2021 WSEC-C – Third Party Cost Benefit Analysis

Report

Washington Department of Enterprise Services

Henry Odum, Evan Green, Jenny Haan, Mark Frankel

Figure 4: Modeled HVAC Energy Savings of Baseline (VAV) and Proposed (VRF) Systems (Kim, 2017)

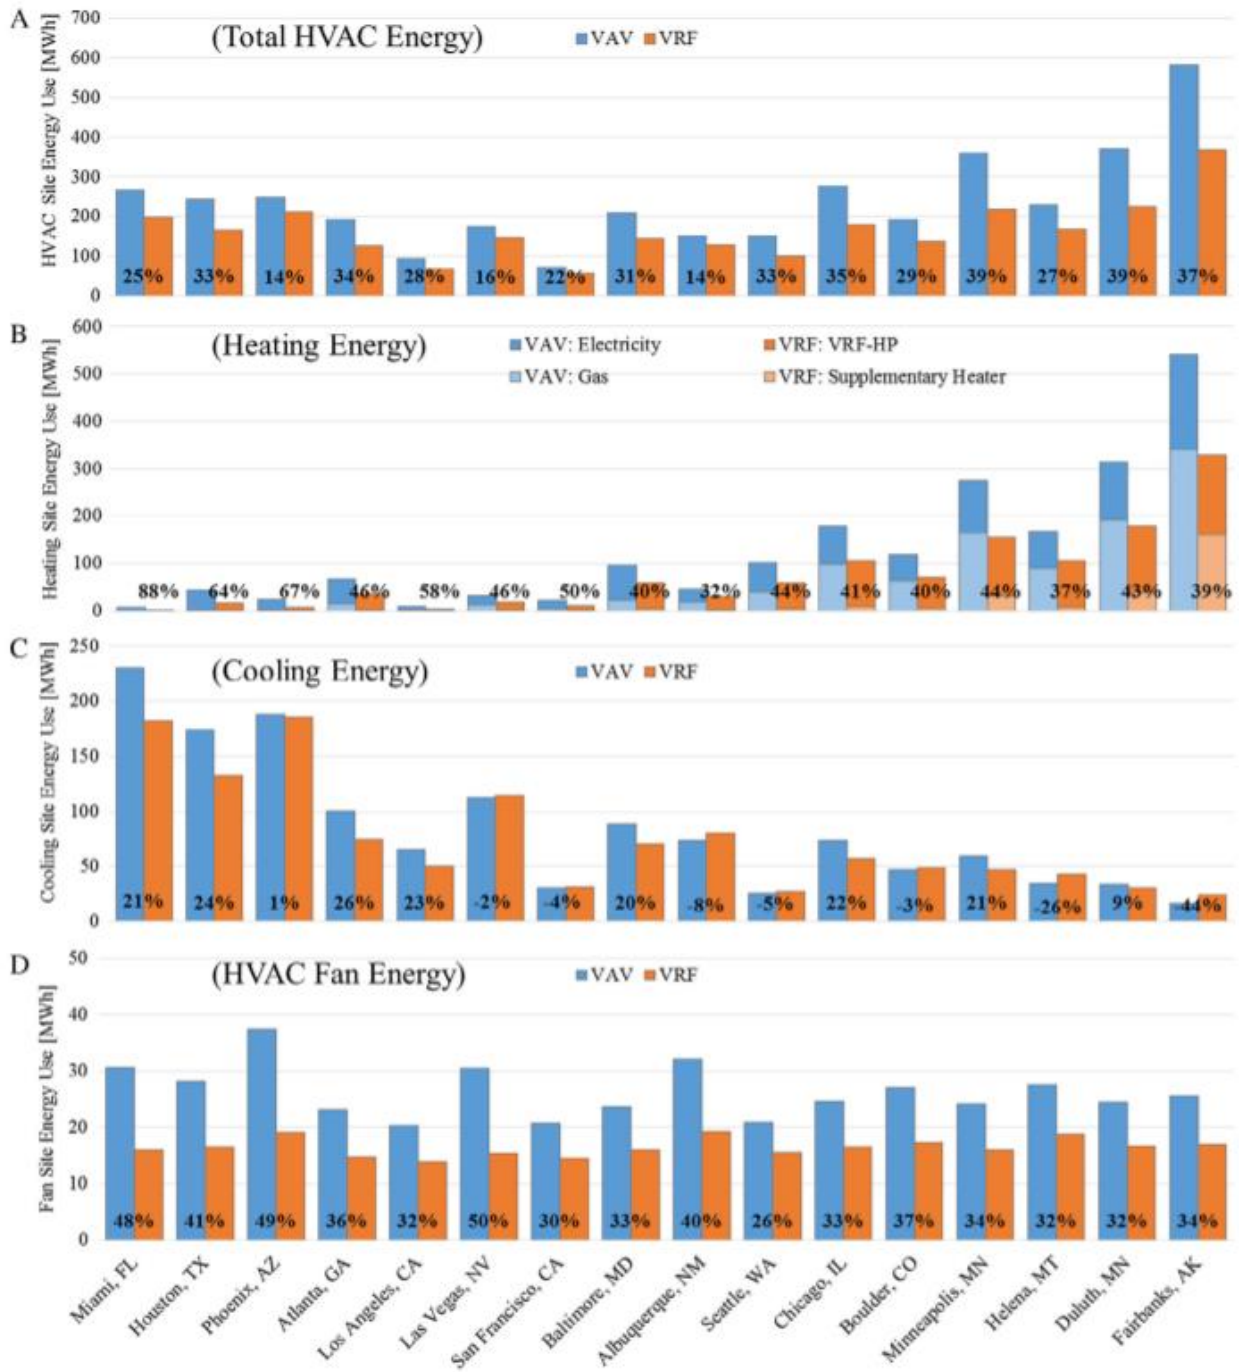
Code change proposal, budget requirements, and efficiency projections were based off a credible source, the California Cost Effectiveness Study (see TRC, EnergySoft, 2019). However, the energy and cost calculations the proponent references for the office building's proposed HVAC system references a system not compliant with the current code proposal. Also, it appears energy savings from unrelated efficient appliances are included in all savings. Ecotope's review is based off the proponent's baseline HVAC reference with data sourced from the Pacific Northwest National Laboratory's (PNNL) life cycle cost analysis of VRF (Thornton, 2011) and a published Elsevier report on the energy savings potential of VRF from VAV in the US (Kim, 2017).

1. Update calculations to be based on compliant source.
→ See PNNL's research and modeling of VRF Life Cycle Cost Analysis and Dongsu Kim, S. J., 2017 report on energy savings potential of VRF.
